National Environmental Consulting

November 22, 2021

Subject: Proposed Modifications to the OU2 Groundwater On-Site Containment System, Tower 96 Treatment System
Northrop Grumman Systems Corporation
Bethpage, New York

SYM	ZONE	DESCRIPTION	DATE	APPROVED
REVISIONS				
DATE	NORTHROP GRUMMAN SYSTEMS CORPORATION BETHPAGE, NEW YORK			
DRAWN	FF			
CHECKED	CT			
ENGINEER	CT	FIGURE 1 PROCESS AND INSTRUMENTATION DIAGRAM AIR PROCESS		
APPROVED	DATE	SIZE	DWG. NO.	REV
TITLE	PROJ. NO. 000.07AS301121			SHEET

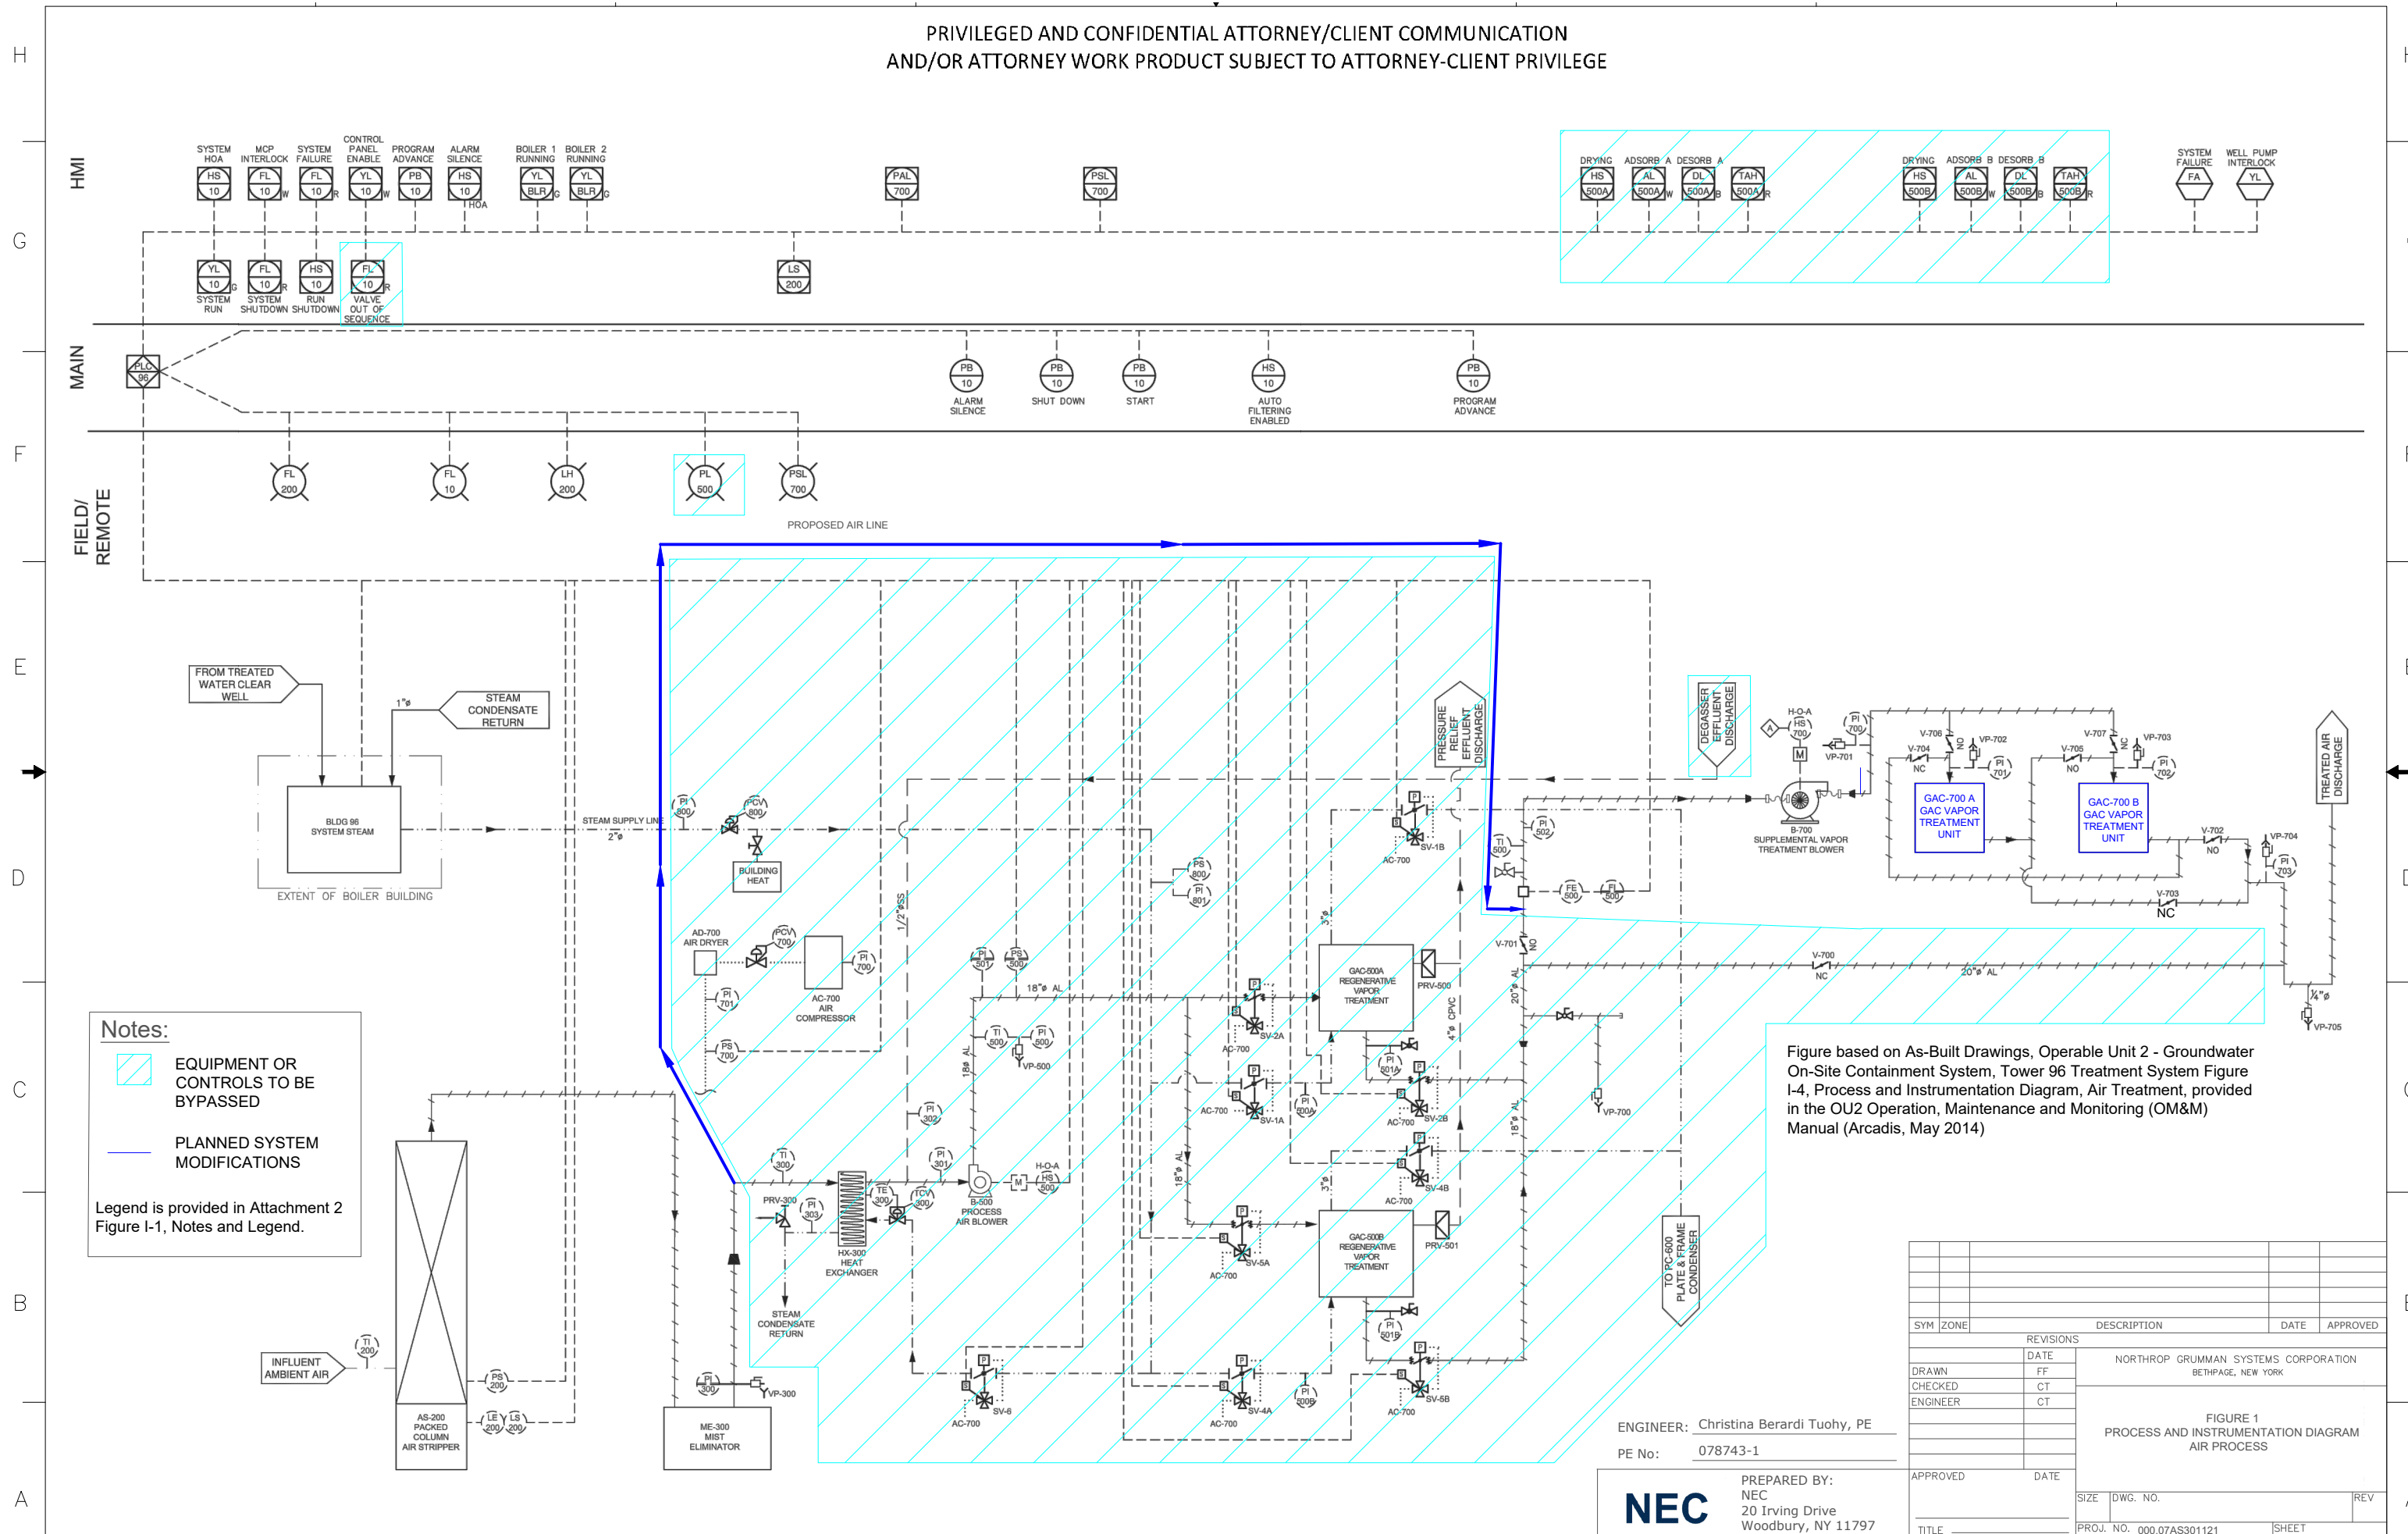
Northrop Grumman plans to bypass the RVPGAC system and associated equipment to provide continued treatment of T96 vapors through the VPGAC treatment units. **Figure 1** illustrates the modifications that will be made to the current system, based on the Air Treatment Process and Instrumentation Flow Diagram provided in the OU2 Operation, Maintenance and Monitoring (OM&M) Manual (Arcadis, May 2014). The modifications are summarized as follows:

1. Bypass the following RVPGAC system equipment inside the T96 building through installation of new duct work using round 6061 aluminum alloy with 0.25-inch wall thickness and welded 0.25-inch-thick flanges and corrosion resistant assembly hardware and connections:
 - a. Vapor treatment steam system;
 - i. Heat exchanger and associated valves;
 - ii. Vapor treatment blower and motor and associated indicators and switches;
 - iii. Air compressor and associated indicator, valve, air dryer and pressure switch;
 - iv. Two RVPGAC units and associated pressure indicators and valves;

- b. Solvent recovery system including:
 - i. Plate and frame condenser and associated, switches, and valves;
 - ii. Decanter and associated level indicator;
 - iii. Solvent recovery tank, pump, transmitter, and level indicator; and
 - iv. Condensate receiving tank and associated level switch and pump.
2. The existing supplemental vapor treatment blower (B-700), which can overcome all losses across the system, will remain on-line. This blower will be evaluated for replacement in the same location in the future.

The T96 RVPGAC system was originally designed to treat a 6,700 scfm air stream with a demonstrated trichloroethene (TCE) removal efficiency of at least 95 percent. The modified T96 system will provide vapor treatment through two 10,000-pound VPGAC treatment units in series (**Figure 1**, GAC-700A and GAC-700B, vapor treatment units). No modifications to the design of the VPGAC units or T96 effluent stack are necessary or planned.

- EQUIPMENT OR CONTROLS TO BE BYPASSED
- PLANNED SYSTEM MODIFICATIONS
